**Crested Butte Mountain Bike Association
GMUG Forest Plan Comments 11.12.2021**

1. Irwin Lake Area – Kebler Pass Drainage

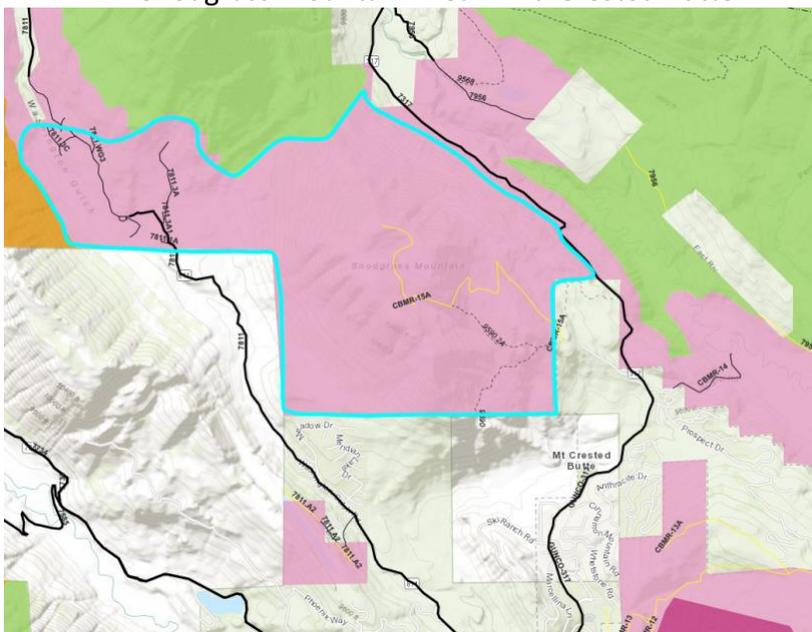
CBMBA has identified and proposed four specific areas that are ideal for stacked/looped trail systems. These proposed areas are close to population centers, are *all* identified as General Forest (5) or Mountain Resort (4.1) in the proposed Forestwide Management Area Maps, and are also *either* identified already as Roded Natural, Rural, Semi-primitive Non-motorized, or Semi-primitive Motorized in the ROS alternatives. They do not contradict or overlap inadvertently with the GPLI proposal, and these areas are appropriate for more progressive stacked/looped trail and recreation amenities like trail features, directional travel (such as uphill only or downhill only), user-specific trails (such as hike or bike only), and decking/boardwalks. CBMBA's Proposed Recreation Emphasis Corridors/Areas are indicated by the light blue boundaries in the images below, utilizing the Alt. B Summer ROS (Interactive Story Map) with imported polygons.
